TO: District of Columbia Zoning Commission
FROM: Stephen Cochran, Case Manager
Jennifer Steingasser, Deputy Director- Development Review & Historic Preservation
DATE: May 1, 2020
SUBJECT: Preliminary Report on Zoning Commission Case No.20-06 – Consolidated and Preliminary Planned Unit Development with Related Map Amendment at 1333 M Street, SE

Figure 1. Consolidated PUD: Building 1, East Tower (referred to in text as Tower 1E)
1st Stage PUD: Building 1, West Tower (in text as Tower 1W) and Building 2

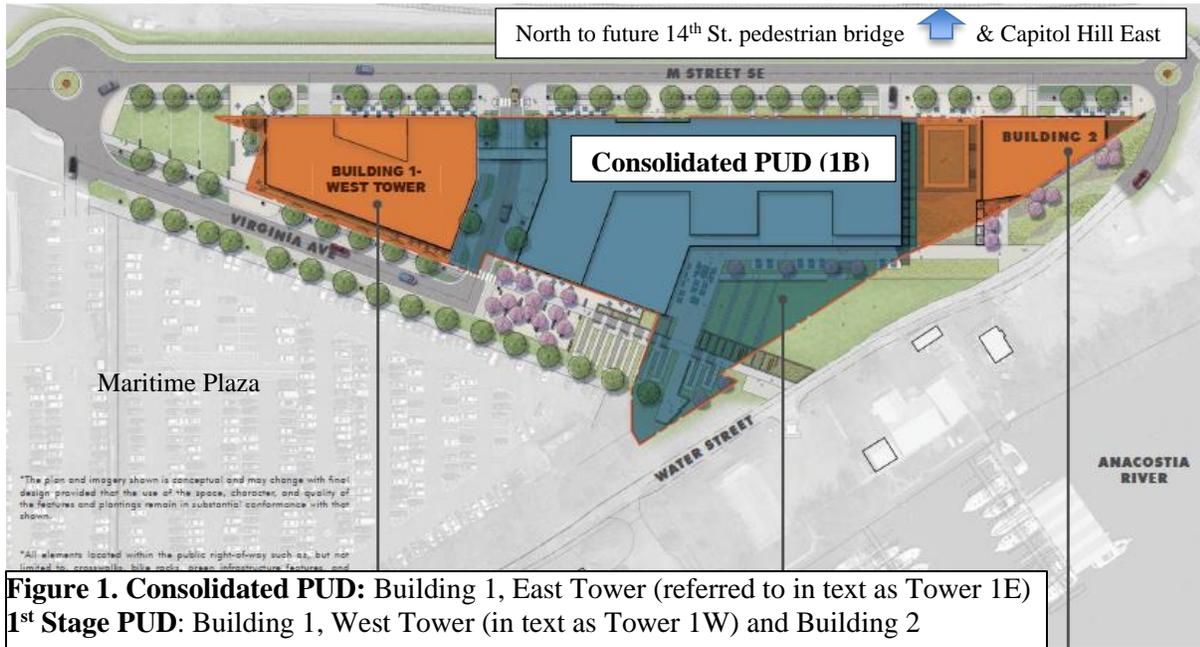
- The Consolidated Planned Unit Development (PUD) with a related map amendment from PDR-4 to MU-9 would be for what is labelled above as Building 1, East Tower (Tower 1E), a 168-space parking garage below both Consolidated PUD Building 1E and 1st Stage PUD Building 1, West Tower (Tower 1W), and infrastructure and landscape improvements detailed below. The 480,200 square foot, 130-foot-tall structure would include:

Figure 5. Consolidated PUD
A. Proposal

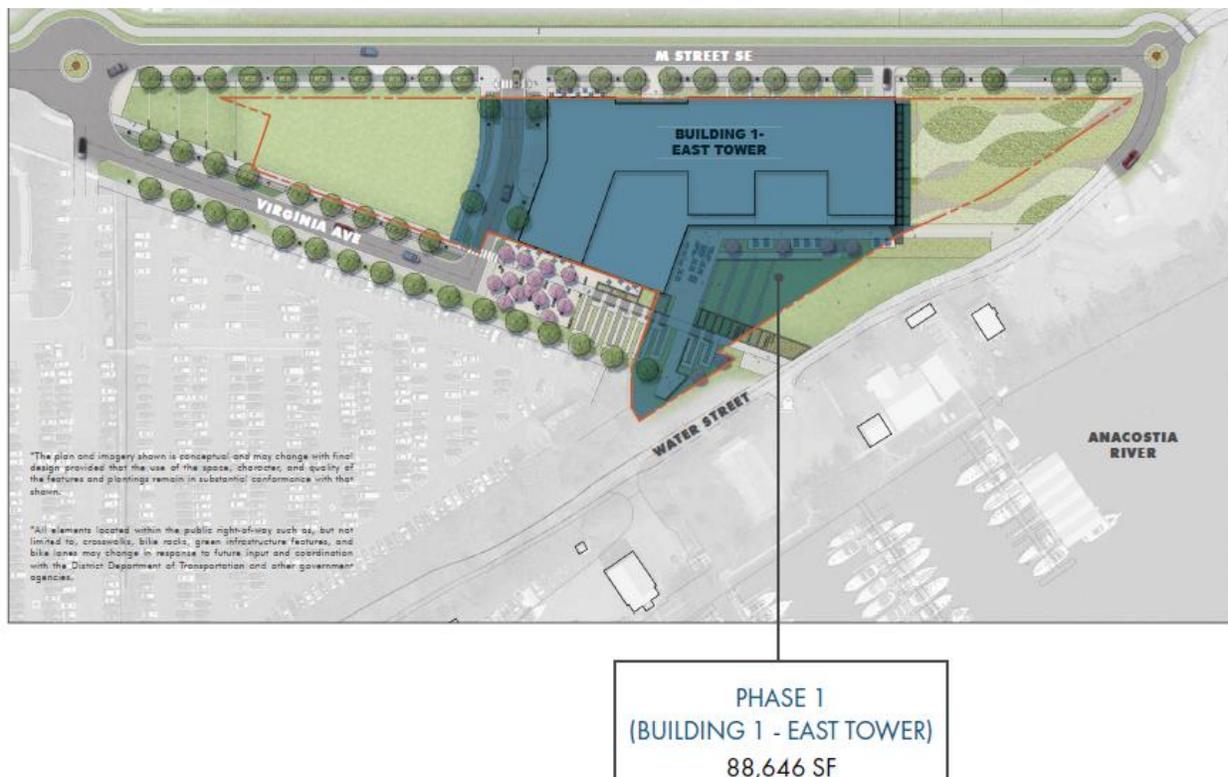
Benefits, amenities and proffers for the total project are listed in Table 2 of this report. Benefits particular to the Consolidated PUD can be inferred from Tower 1B's uses and affordable housing and the landscape improvements shown in the plan drawings for the Consolidated PUD. However, the applicant should submit a list of specific benefits to be provided in just the Consolidated PUD phase.

OP has encouraged the Applicant to study ways in which the different façade approaches in the Consolidated PUD could be better integrated with each other and will continue to work with the Applicant to study and refine the building's design with the following concerns in mind:

- The establishment of a subtler interplay among the elements of the contrasting traditional and modernist facades;
- Enhancement of the visual permeability of the facades suggested by multi-story opening in the modernist portion of the façade;

- Increasing connectivity between the upper and lower terraces on the south side of the tower;
- Detailing retail signage proposals on the north, south and west faces of the tower;
- Ensuring that the pedestrian overlook and connection on the east side of the of the tower is designed for access to the lower level by a range of users;
- Adding a bicycle channel to the Virginia Avenue stairs.
